# GROTTO ENGINEERING ASSOCIATES, LLC

April 26, 2024

Subject: Completeness Review No. 3  
Home & Land Development Corp.  
14 & 32 North Peak Street  
Block 35, Lots 8 & 9  
Borough of Highlands, Monmouth County, New Jersey  
Our File No.: PR-0290

1. HLPB2022-10 - COMPLETENESS REVIEW #3 – (February 20, 2024) – Carmela Roberts, P.E., C.M.E., C.P.W.M., Land Use Board Engineer

### COVER SHEET

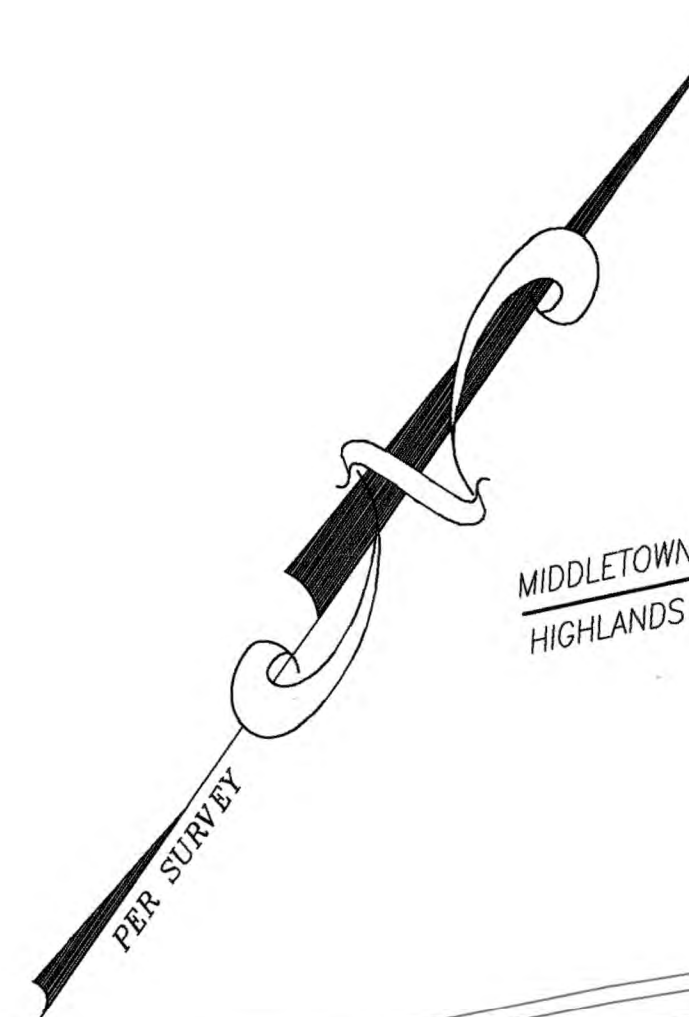
*Incomplete. The latest submission does not provide existing bulk requirements and proposed lot coverage. Refer to plan sheet 3 of 3.*

**This office has calculated and shown various bulk requirements and proposed conditions, including lot coverage. Refer to plan sheet 1 of 8.**

**UTILITY PLAN**

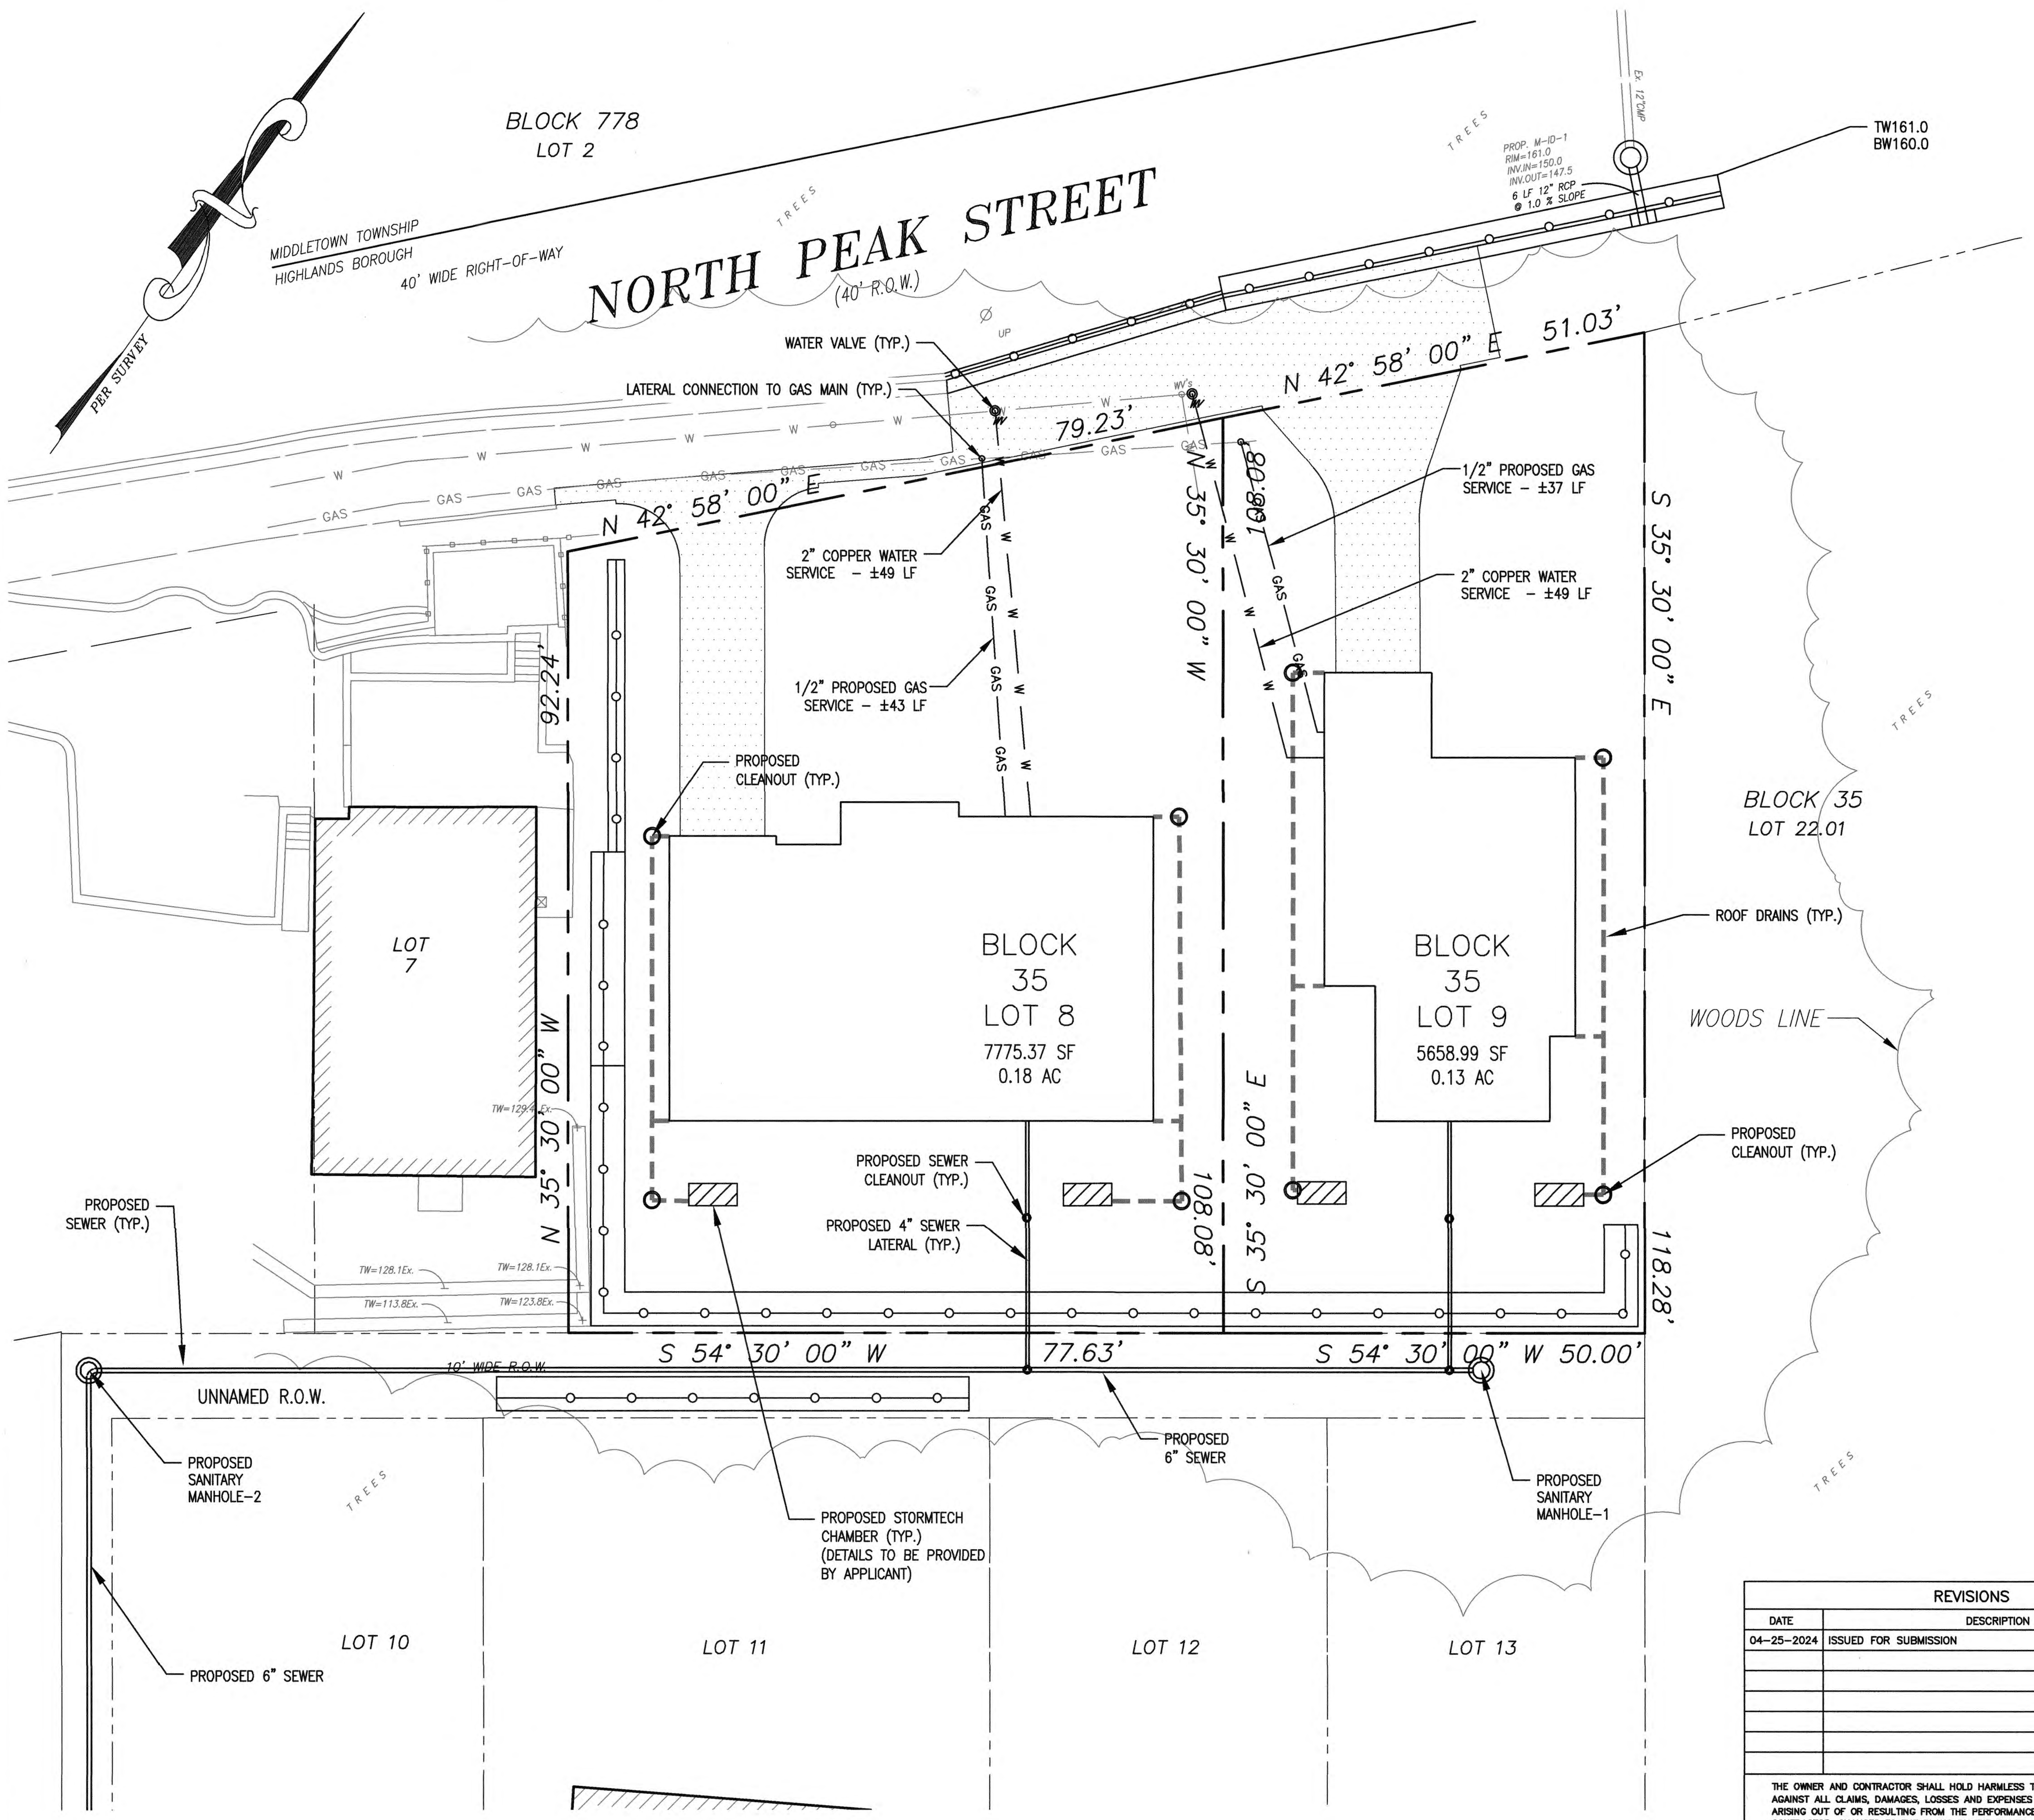
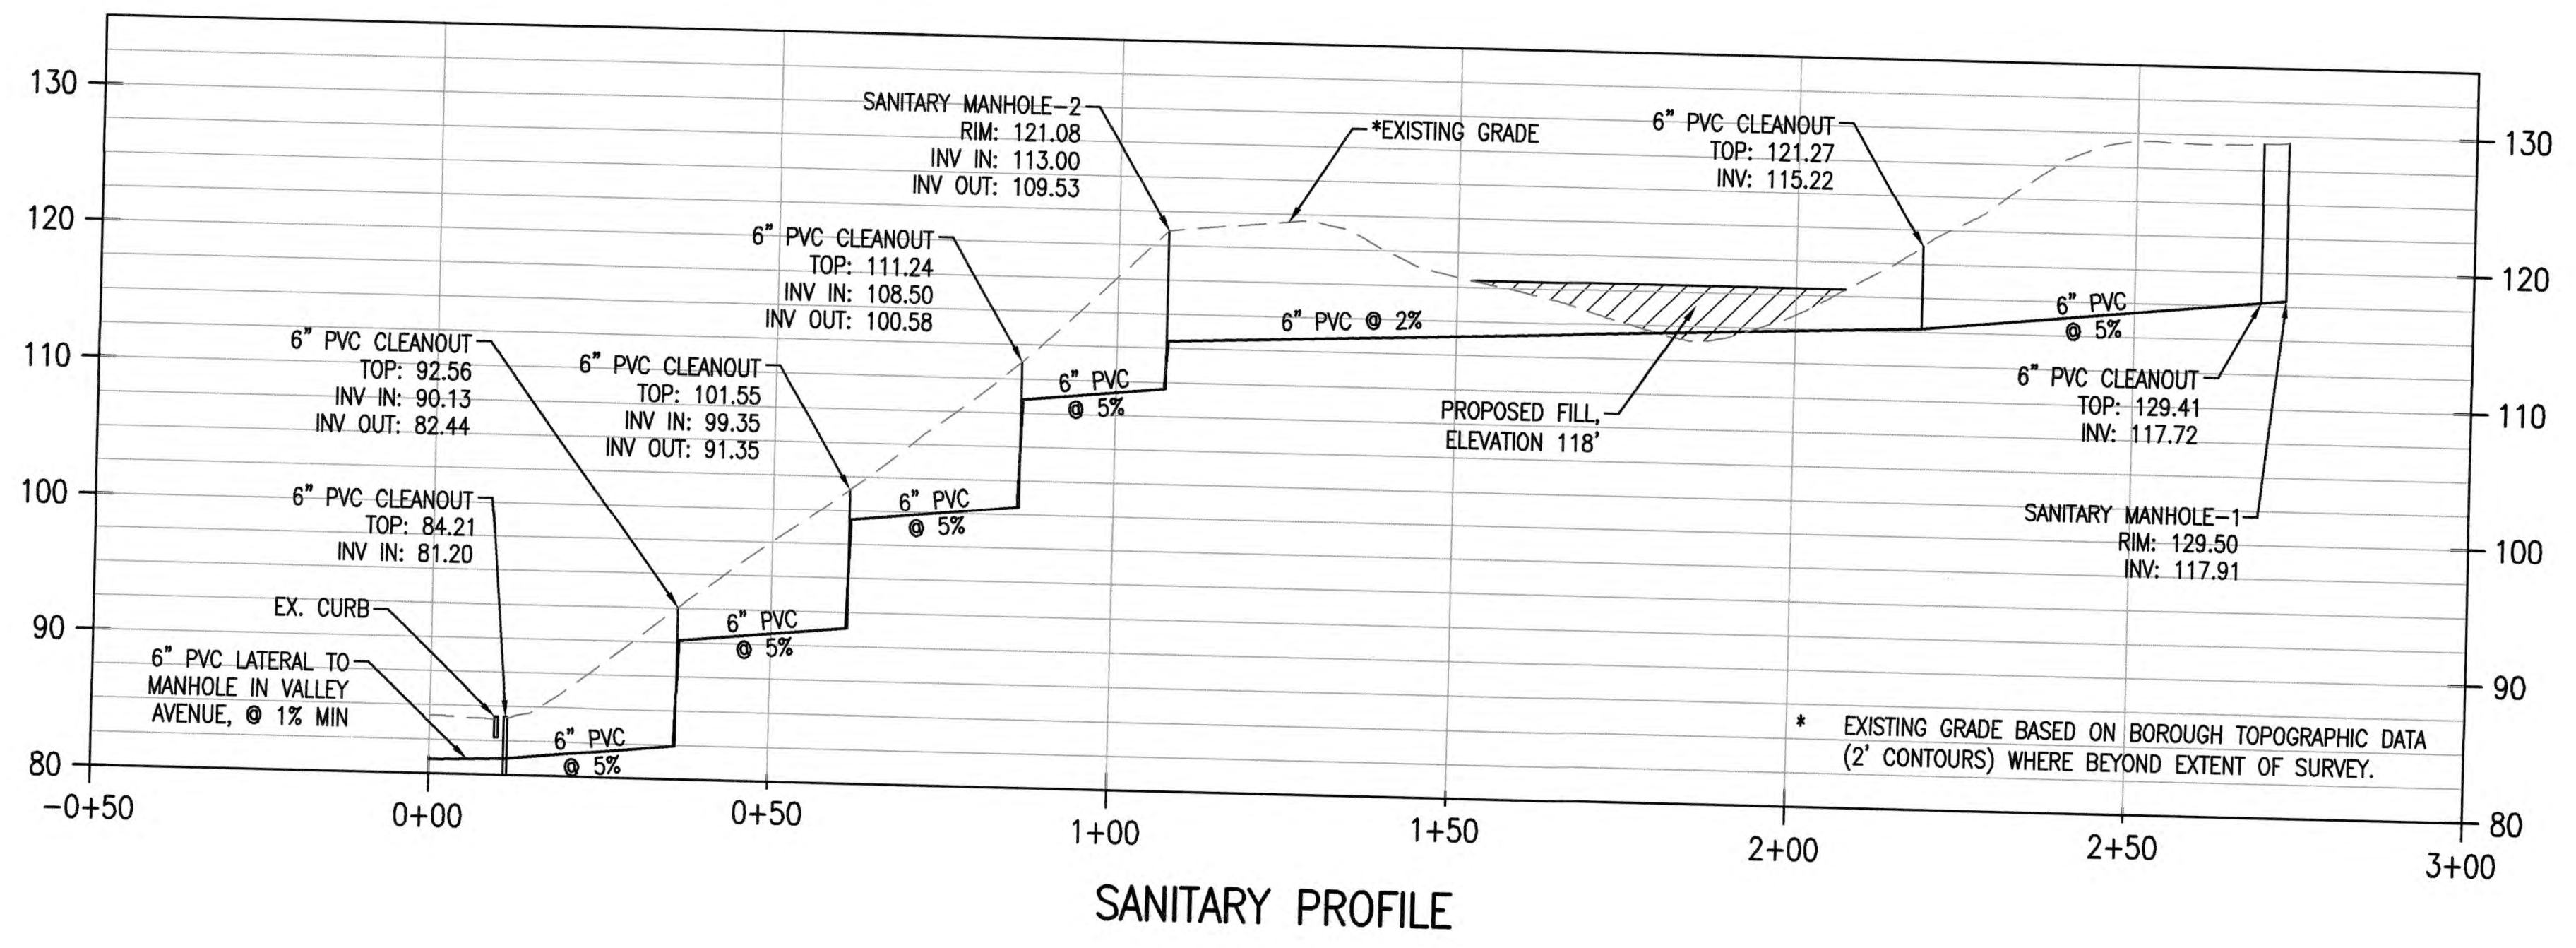
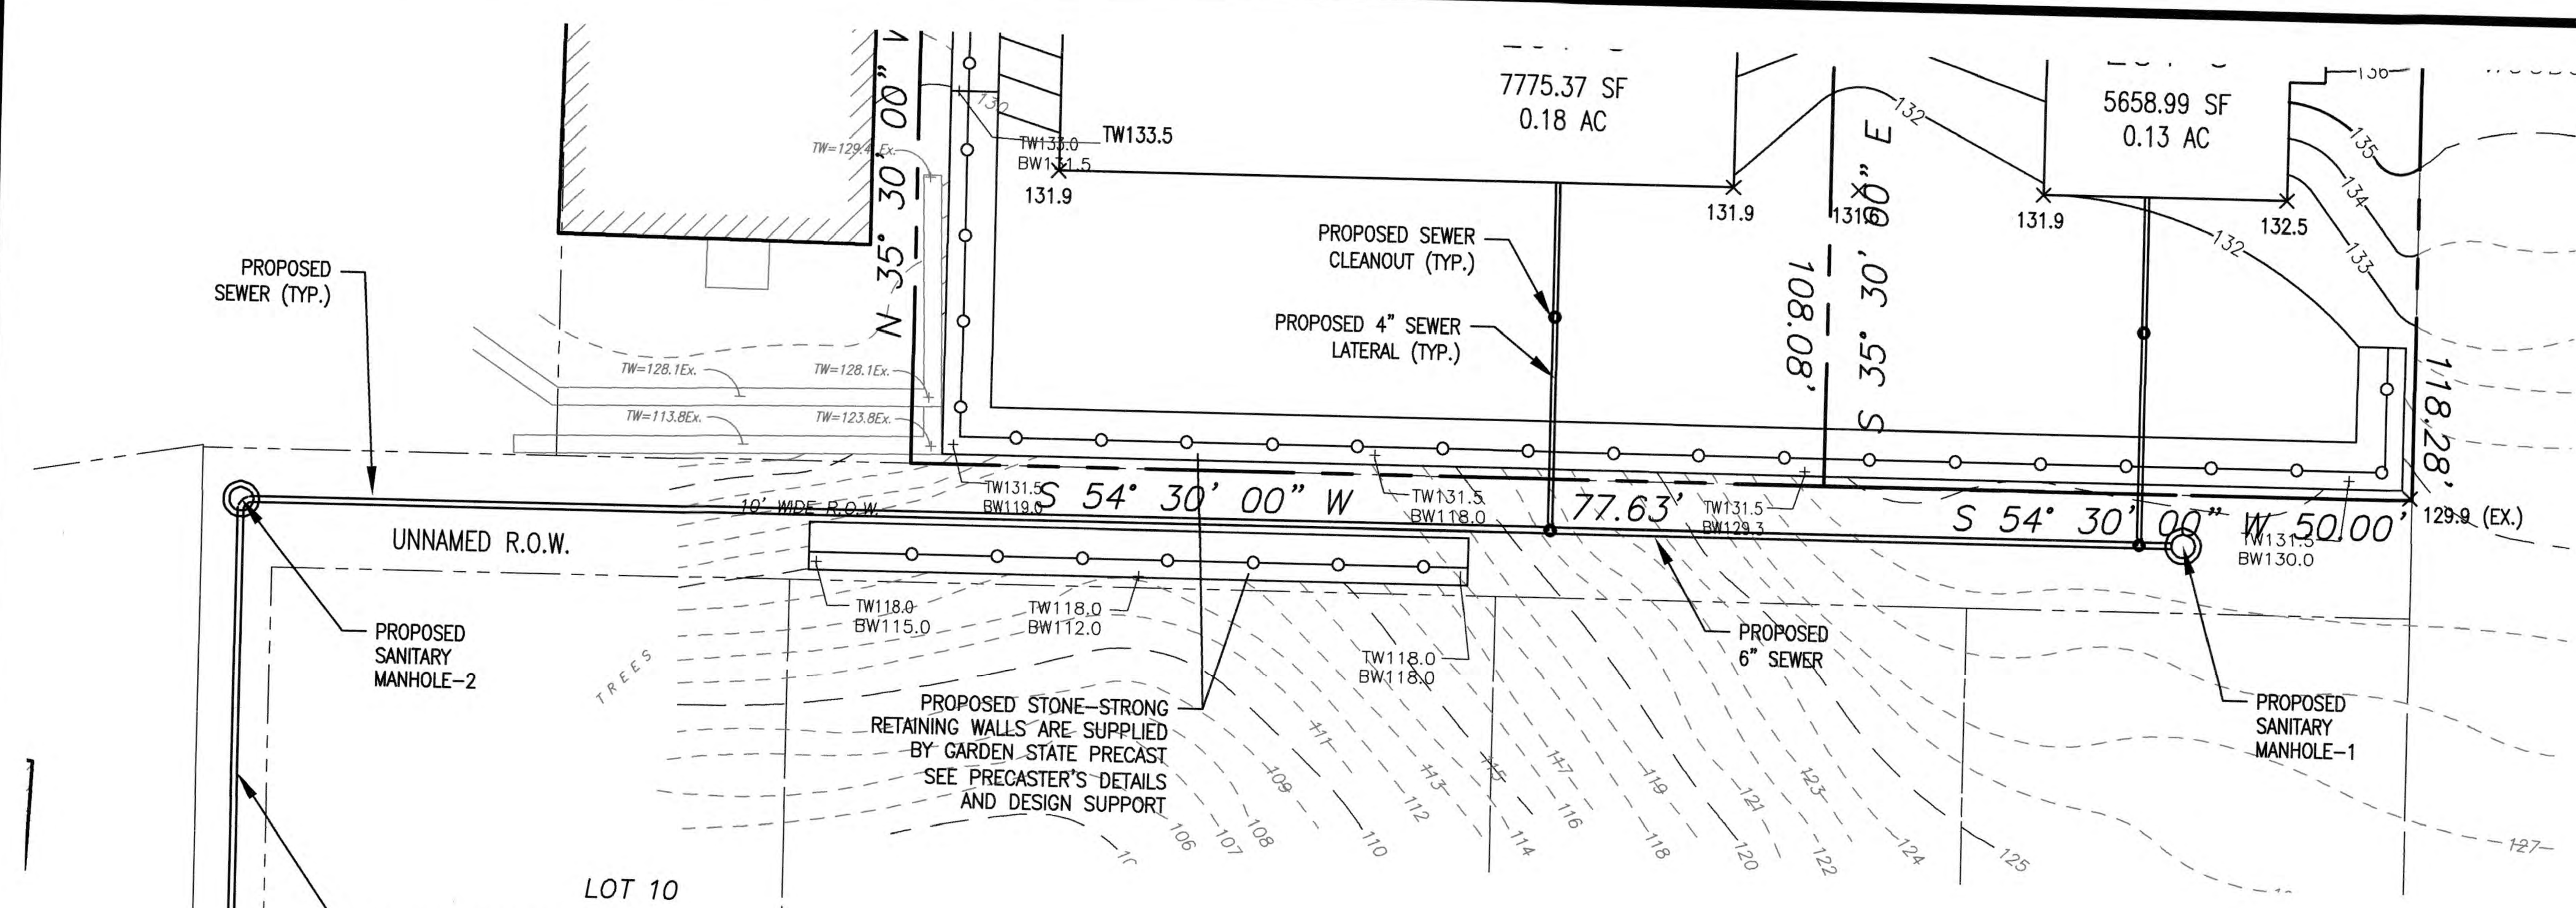
The existing water and gas lines extending into the lots including any meters and cleanouts must be shown on the Minor Subdivision and potential grading plan.

Confirm that there are no utility easements on the existing lots. A portion of the existing pavement and utilities are not within the North Peak Street 40 ft. wide R.O.W.

**Proposed water and gas connections have been added to the utility plan.**

**Existing water and gas lines have been shown on the plans and shall be field verified by the contractor prior to construction.**

**There are currently no utility easements on the existing lots. Proposed pavement and utilities are located within the North Peak Street 40 ft. wide R.O.W.**
